# DA MODIFICATION ADDENDUM NO. 3 to Environmental Impact Statement

**Lookout Road Quarry**

DA 2015-953

March 2019

#### Illustration 1.1 Approved and Modified Dam Location

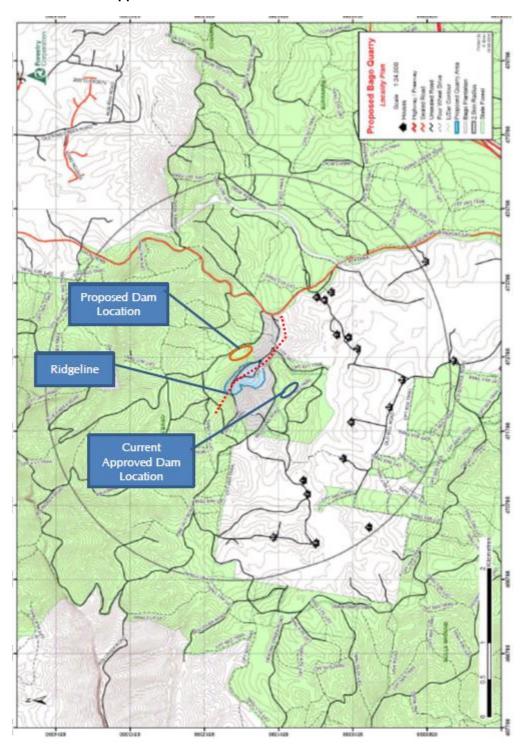
The originally approved position of the dam has subsequently been shown to be inappropriate.

As a result of recent geological investigation, together with a recent ecological review, and supported by a review of constructability, it has become abundantly clear that it is not feasible to construct the water storage dam in the position shown in the original DA drawings.

Accordingly, it is necessary to change the location of the dam. A more suitable location has been found elsewhere on the subject land.

The application seeks to relocate the position of the water storage dam (and the pump house) associated with the approved quarry.

The proposed (preferred) location of the dam is situated in a second order stream within the subject land approximately 100 m to the north east of the south-eastern corner of the approved quarry precinct.

# **Appendices Concept Drawings**

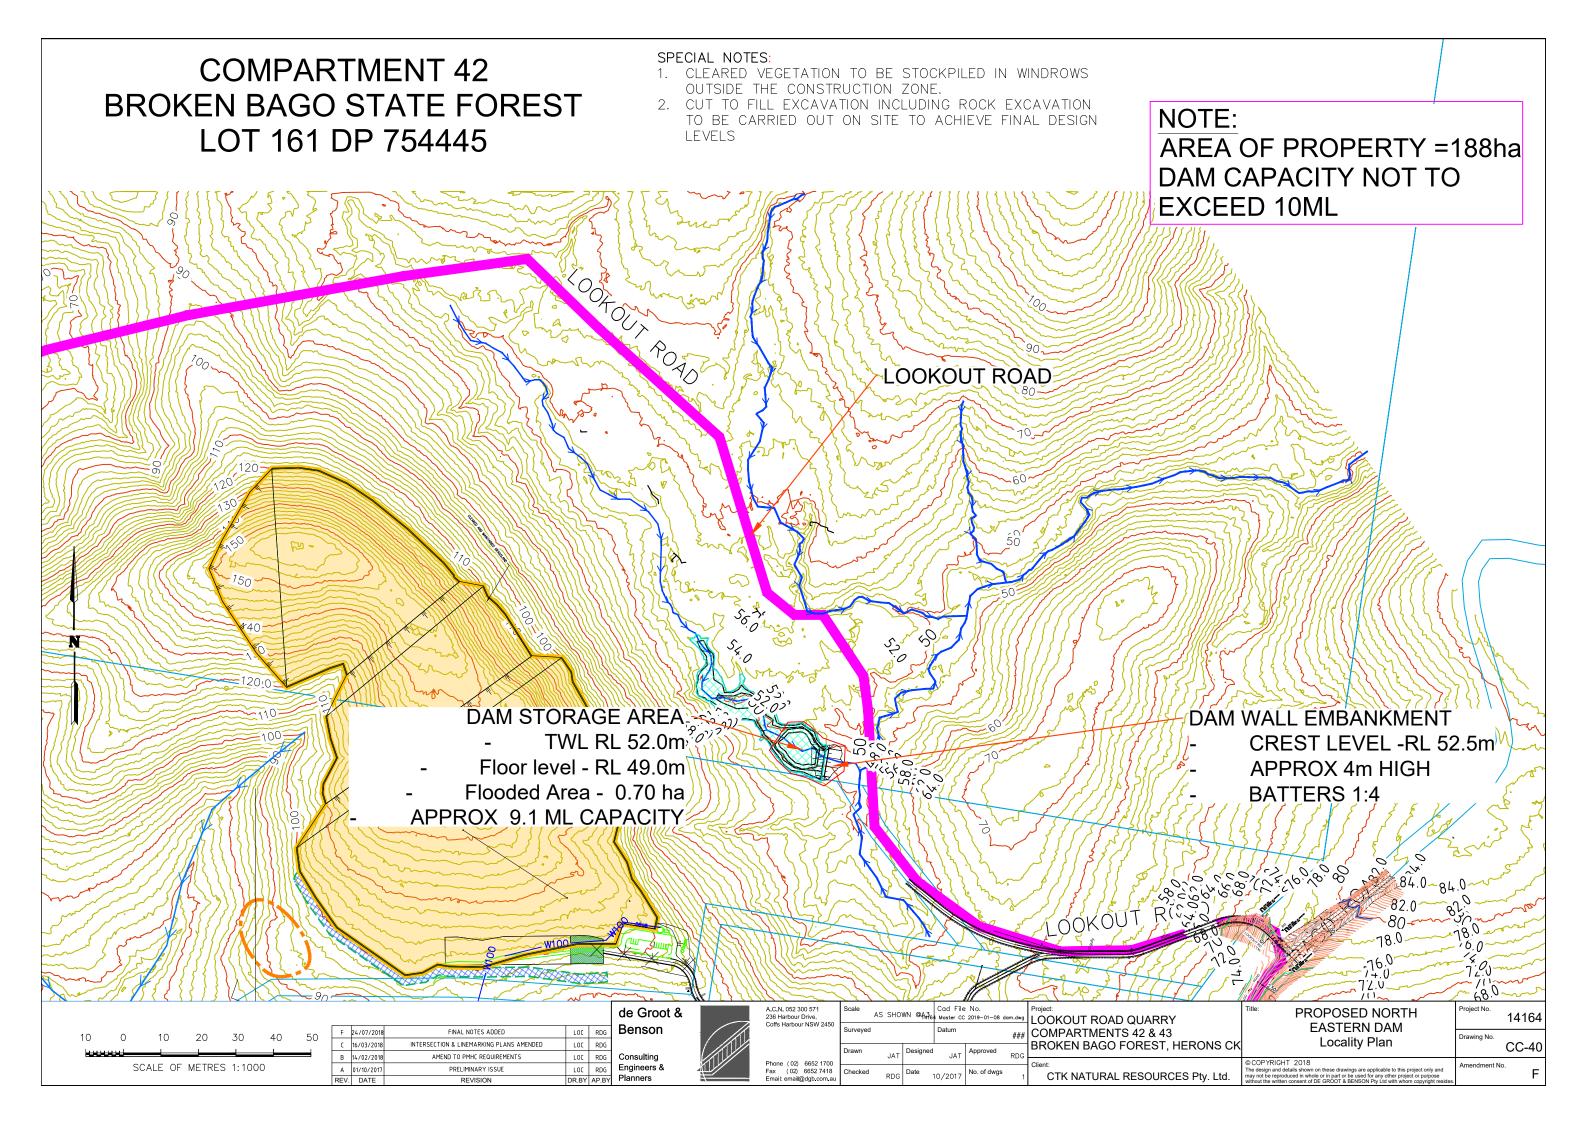
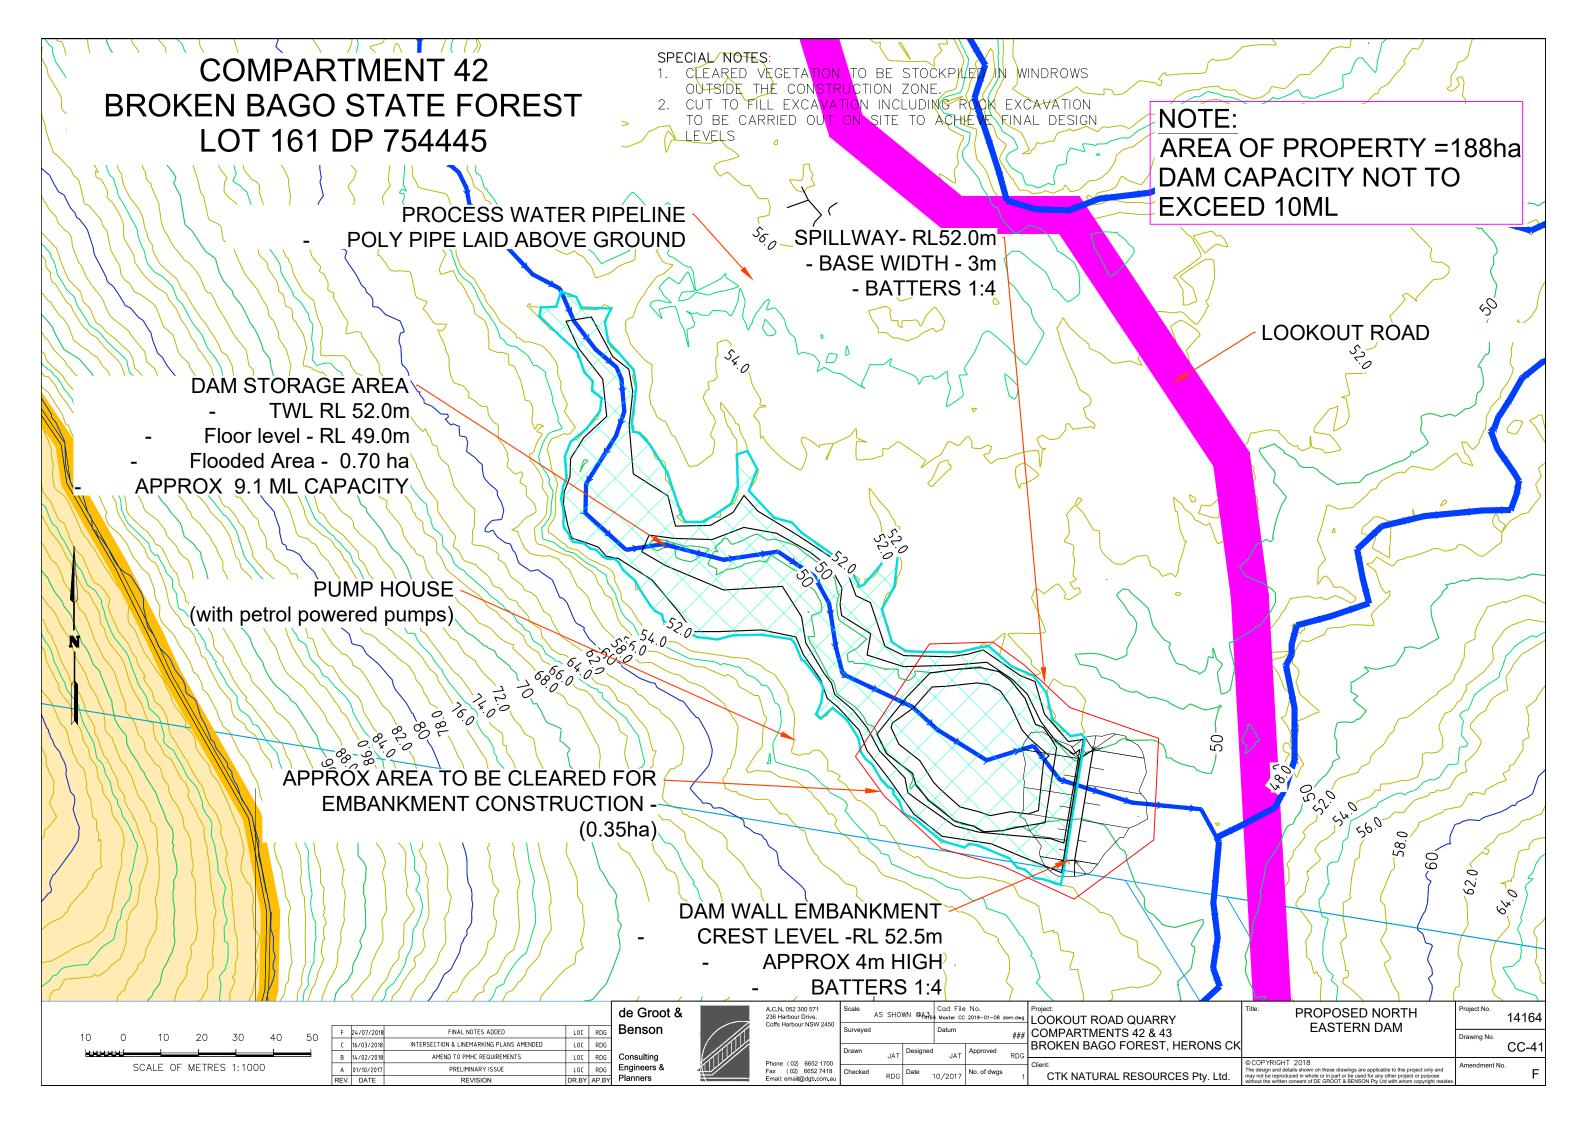
The location and the conceptual engineering attributes of the dam are illustrated on the drawings which accompany this application.

Those drawings demonstrate that the currently proposed dam site is further away from all of the dwellings within the district than the originally approved dam site. Furthermore, the proposed dam site is situated in a totally separate catchment to the regional dwellings. A significant ridgeline now separates those dwellings from the proposed dam and pump house.
